Subject: Longwall 309 First Workings Layout

Figure 1 – Revised Longwall Layout – Longwall 309

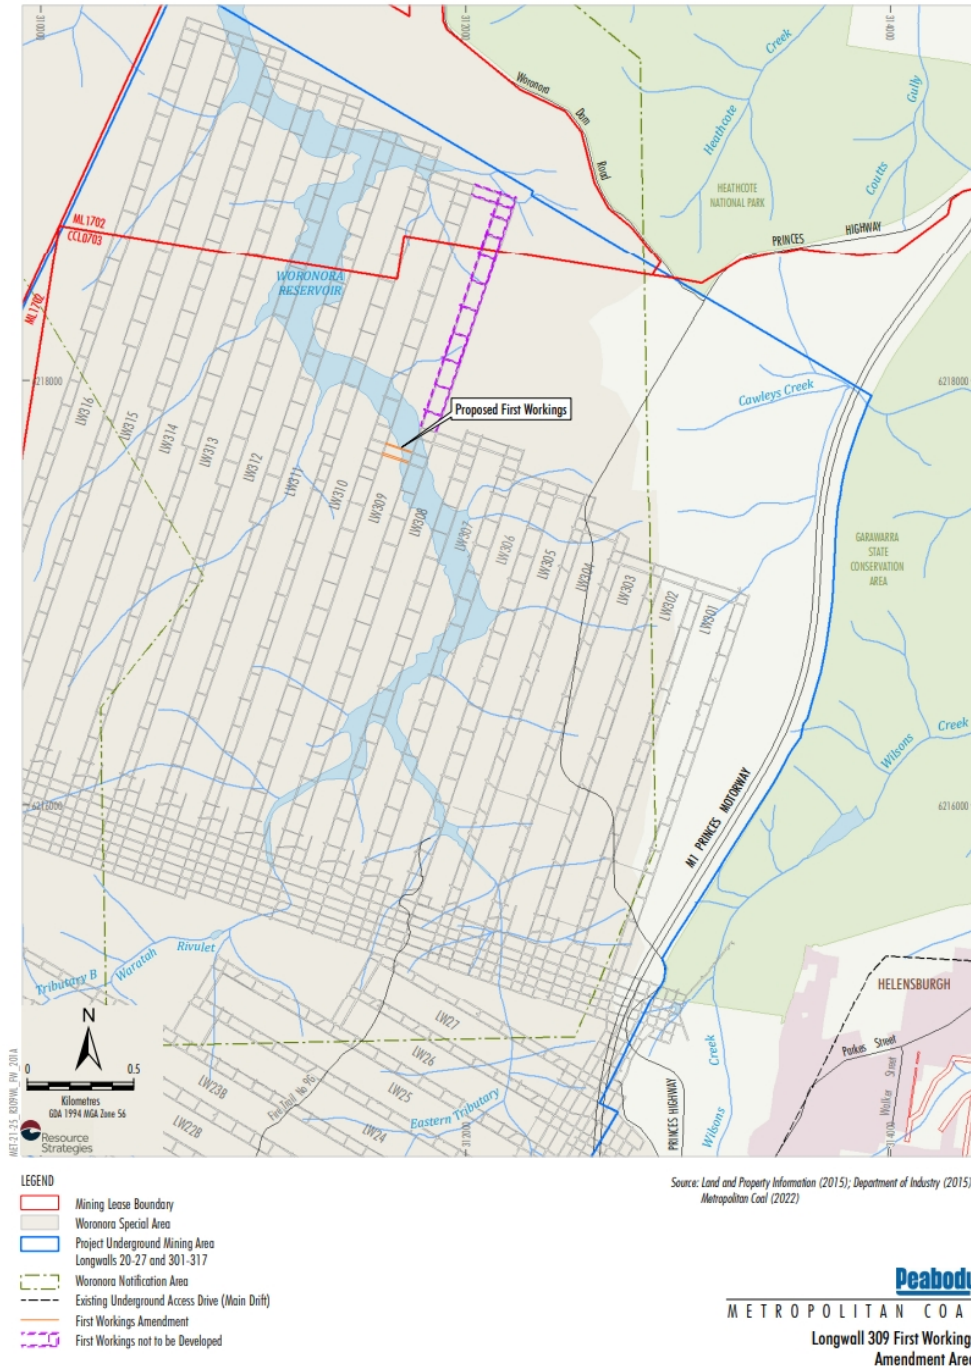
I refer to your submission dated 20 October 2022, requesting approval to vary the first workings of Longwall 309 (LW 309) from the length originally approved under the Metropolitan Coal Project Preferred Project Report as shown on **Figure 1** (see attached).

The Department notes that revised layout would not change the currently approved panel width, pillar width or panel orientation. The first workings would be non-subsiding and would not result in increased subsidence effects.

The Department consulted with the Department of Regional NSW – Mining, Exploration & Geoscience (MEG) and the Resources Regulator. MEG noted that it is satisfied that the revised first workings for LW 309 would allow for maximised recovery of resources from within the Bulli Seam and would provide an appropriate return to the State. The Resources Regulator did not identify any specific concerns regarding mine safety or mine subsidence matters as a result of the revised first workings.

The Department is satisfied that this change to the proposed first workings would be unlikely to result in additional subsidence impacts. Accordingly, as nominee of the Planning Secretary, I approve the revisions to the first workings of LW 309 as shown in **Figure 1**.
